Informal ad hoc Expert Group on the
Computerization of the TIR procedure

Updates of the Reference Model of the TIR Procedure

1.6 High level class diagram

Proposed changes to the Reference Model

Figure 1.21 Consignment class and its relationships

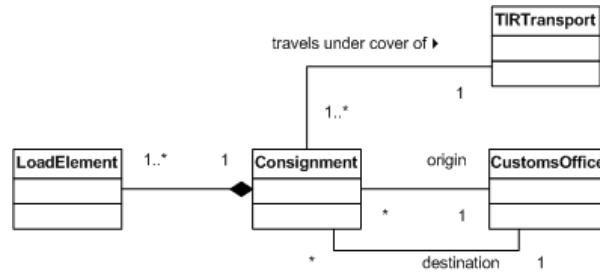
Replace the sub chapters TIR Consignment and TIR consignment element by the two following sub chapters.

Consignment

Name	Consignment sub class diagram
Description	Sub part of the high-level class diagram presenting the Consignment class and all relations with other classes.
Central Class	Consignment
Example instance of the central class	<ul style="list-style-type: none"> o 200 kg of chocolate and 300 kg of almonds loaded in Bern transported under cover of TIR Carnet N° XC380000ZZ with destination Budapest. o 10 cars loaded in Turin transported under cover of TIR Carnet N° XC380000WW with destination Bratislava. o ...
Associated Classes	TIR transport, Load element, Customs office.
Associations and constraints	<p>A consignment is associated to one and only one TIR transport. A TIR transport can carry from one to many consignments. (Req. b)</p> <p>A consignment is composed of one to many load elements. A load element is part of one and only one consignment. (Req. c)</p> <p>A consignment has one and only one Customs office of destination. A Customs office can be the destination of numerous consignments. (Req. d)</p> <p>A consignment is loaded at a single Customs office, called the origin. A Customs office can be the origin for any number of consignments. (Req. f)</p>

Requirements Covered	b, c, d and f

Figure 1.22 Load element class and its relationships

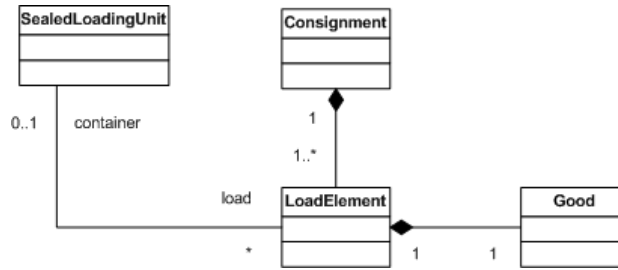
Load element

Name	Load element sub class diagram
Description	Sub part of the high-level class diagram presenting the Load element class and all relations with other classes.
Central Class	Load element
Example instance of the central class	<ul style="list-style-type: none"> ○ 200 kg of chocolate transported under cover of TIR Carnet N° XC380000ZZ and stored in the container xxxxx. ○ 10 cars transported under cover of TIR Carnet N° XC380000VV with destination Budapest. ○ ...
Associated Classes	Sealed loading unit, Consignment, good, Customs office
Associations and constraints	<p>A sealed loading unit can contain any number of load elements. A load element must be contained in one and only one sealed loading unit, except in case of heavy and bulky goods (HBG), where the load elements are not contained in a sealed loading unit. (Req. a)</p> <p>A consignment is composed of one to many load elements. A load element is part of one and only one consignment. (Req. c)</p> <p>The load element is composed of a single good type. (Req. e)</p>

Requirements Covered	a, c and e
